# Report of the Director of Regeneration to the meeting of the Shipley Area Committee to be held on 16 March 2016.

One objection received to the proposed Speed Limit Order to introduce a 20mph zone on a section of Sun Lane, Burley in Wharfedale.

This report considers one objection received to the advertised proposal to introduce a 20mph zone on the existing one-way section of Sun Lane (between its junctions with Main Street and West View Road) in Burley In Wharfedale.

12.1 Appendix 1, Drawing no. TDG/THN/AS/102346/CON/-1B showing the proposals

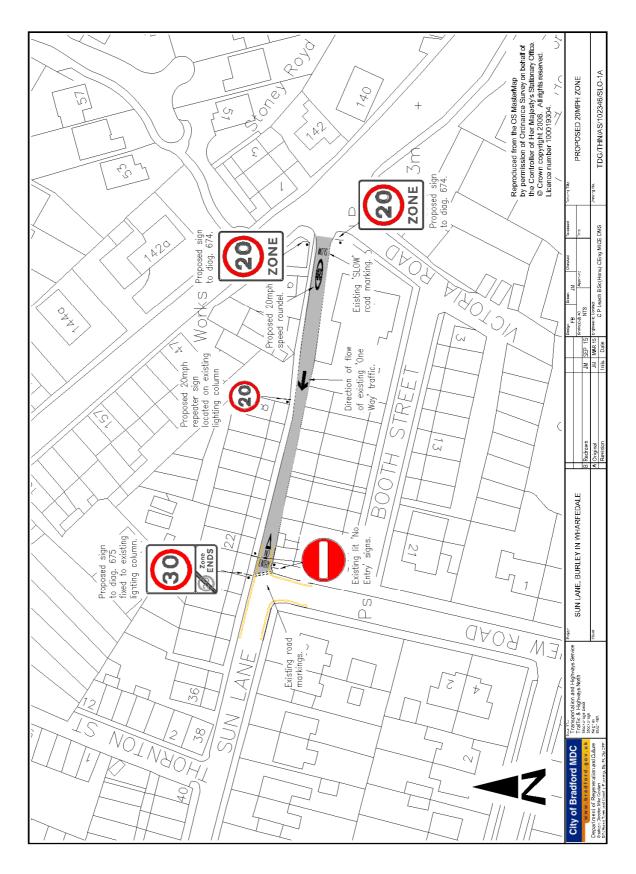
Objector's Comments	Officer's Comments
I object to the proposed 20mph zone on Sun Lane because I am unable to ascertain the reasons behind these proposals and what they are aiming to address.	Over the last few this Committee has received concerns from local residents regarding traffic speeds and driver behaviour on this narrow one-way road. The receipt of only a single objection suggests the scheme proposals are supported by Sun Lane residents.
<ul> <li>I do not believe that the proposed 20 mph zone scheme would address the issues it aims to solve.</li> </ul>	<ul> <li>Although the site's road safety record presents limited potential for casualty reduction, the scheme's primary aim is to address local concerns causing residents anxiety.</li> </ul>
<ul> <li>Have alternative traffic measures schemes been considered for Sun Lane?</li> </ul>	<ul> <li>During the feasibility stage, a number of other traffic management measures including installing vertical and horizontal features were explored but considered inappropriate.</li> </ul>

When were the street notices placed on Sun Lane?	The legal notices advising of the scheme proposals were erected on Sun Lane on Thursday 14 January 2016 for three weeks, ending on Friday 5 February 2016. The Notices were also published in the local press.
<ul> <li>The proposed signage cannot be placed as described by the order as it would obstruct pedestrians and affect local aesthetic.</li> </ul>	<ul> <li>It is not considered that the proposed sign poles will obstruct pedestrians and every possible effort will be taken to minimise the impact of the proposed signs in the area.</li> </ul>
